**PCN Reference:** LFPCN230428

**Subject:** Inner box packing Label update for Medium Power modules

Littelfuse would like to notify you about implementing inner packing box label change for its **Medium Power Modules** built in our different assembly locations.

Type of label	Inner packing box
Before	
After	 <p data-bbox="651 1814 906 1845">Pb-free logo removed</p> <p data-bbox="1016 1814 1224 1845">RoHS logo added</p>

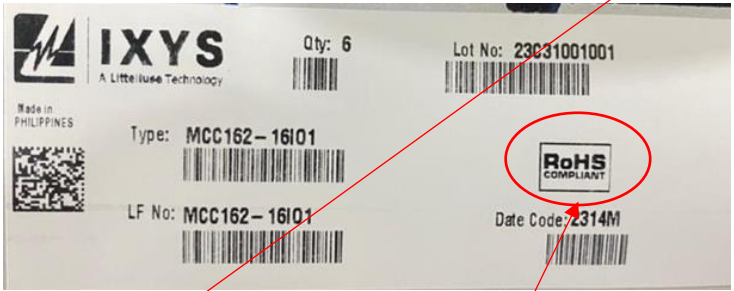
To harmonize the marking, we will remove Pb-Free marking which is not relevant to all our products portfolio and will only show up a “RoHS compliant” logo which is appropriate to all our power modules.
